RIVERWALK 1ST ADDITION
POND M REVISIONS

# RIVERWALK P.U.D. 1ST ADDITION
# SUPPLEMENTAL RECORD DRAWING
## INDIANA AVENUE POND DETAILS
### SEC. 8, T.25 N., R.45 E.,W.M.
### SPOKANE COUNTY, WASHINGTON

RIVERWALK 1ST ADDITION
INDIANA AVENUE
SUPPLEMENTAL RECORD DRAWING

RIVERWALK 1ST ADDITION
SUPPLEMENTAL RECORD DRAWING

DESIGNED CROSS-GUTTER
1"=10'

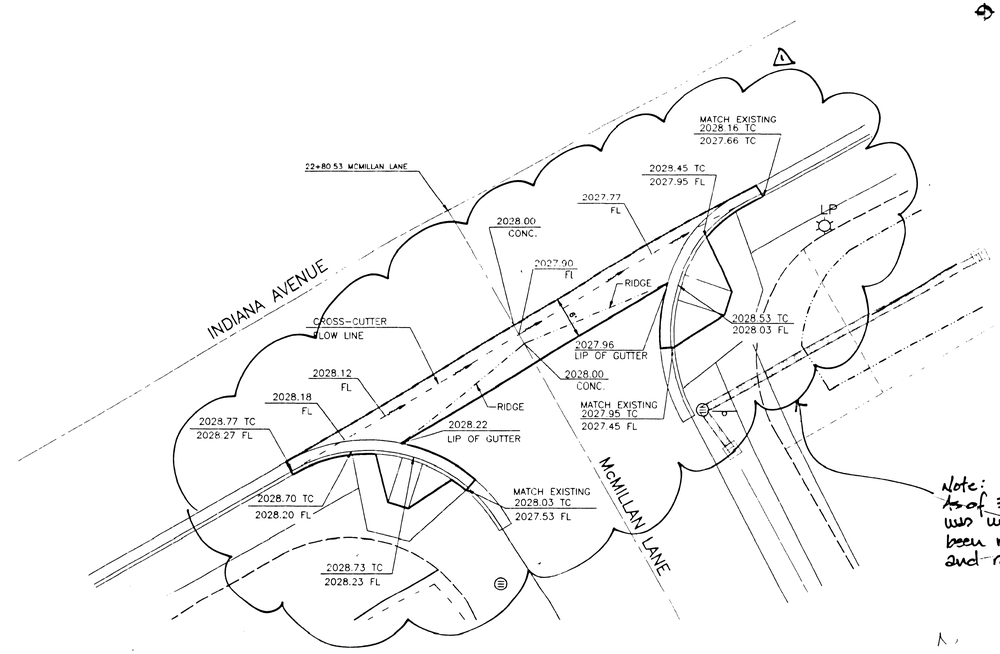
Note:
As of 3·27·97 the cross gutter was not accepted and has been requested to be removed and re-constructed.
TRW
3·28·97

LOT 13, BLOCK 1 SIDEWALK REALIGNMENT
1"=20'

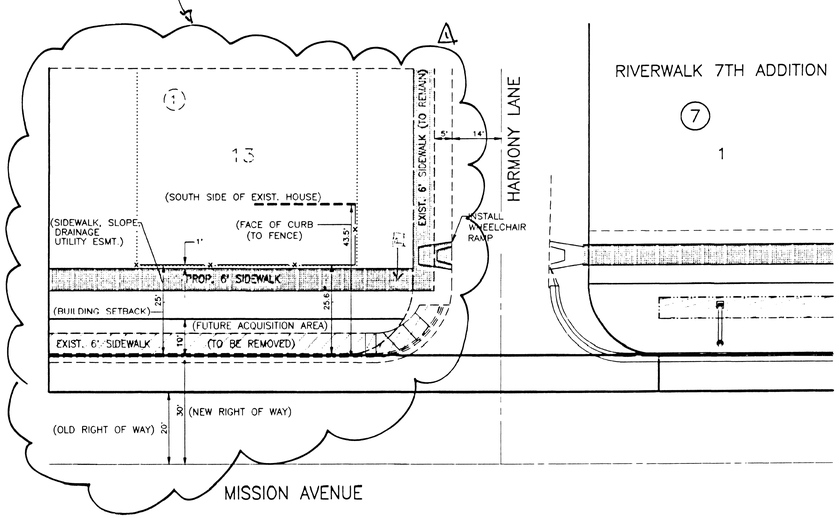
Note:
As of 3·27·97 the existing 6' sidewalk has not been removed and reconstructed to the location noted as "PROP. SIDEWALK".
TRW
3·28·97
